## Alpha Replacement Shift Cable

All MC-I, R, MR, Alpha One and Alpha One Gen II

- a** - Older style shift cable core wire with round anchor
- b** - Newer style shift cable core wire with hexagonal anchor

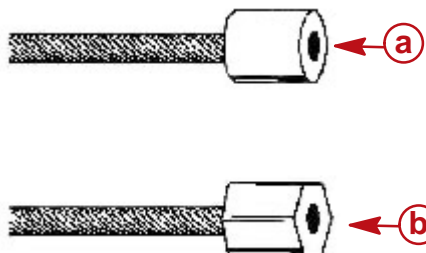
The newly redesigned Alpha intermediate shift cable may experience stiff shifting caused by binding at the aft end of the cable. If the binding occurs, the stiff shifting could cause the engine to stall. The binding is caused by the hexagonal shaped anchor attached at the aft end of the cable. This hexagonal anchor has a slightly larger outside diameter than the older style round anchor. Due to the larger outside diameter, there may be an interference fit between the hexagonal shape cable anchor and the inside of the shift slide. **Note: Shift slide must rotate freely on core wire to prevent hard shifting and/or engine stalling when shifting the drive.**

Inspect your inventory of the following shift cable assemblies P/N 19543A 8 and P/N 19543T 1. If the cable core wire has a round shaped anchor, your inventory is good and it does not need to be replaced. If the shift cable core wire has a hexagonal shaped anchor, it must be returned to Mercury Marine for credit.

P/N 19543A 8 will be superceded to P/N 19543A10 and P/N19543T 1 will be superceded to P/N 19543T 2. The new superceded P/N 19543A10 and P/N 19543T 2 include the new style shift cable core wire with the hexagonal anchor and the new modified shift slide P/N 850752 2 designed to accommodate the larger hexagonal anchor.

The shift slide P/N 850752 1 can be used up with the older shift cables that have a round core wire anchor. The P/N 850752 1 will be superceded to P/N 850752 2. The initial modified shift slides P/N 850752 2 will be identified by a yellow paint dot on the starboard side of the shift slide. The later shift slides will be identified by a "2" cast in the top of the shift slide.

P/N 19543A10	Shift Cable Assembly – replaces 19543A 8
P/N 19543T 2	Shift Cable Kit – replaces 19543T 1
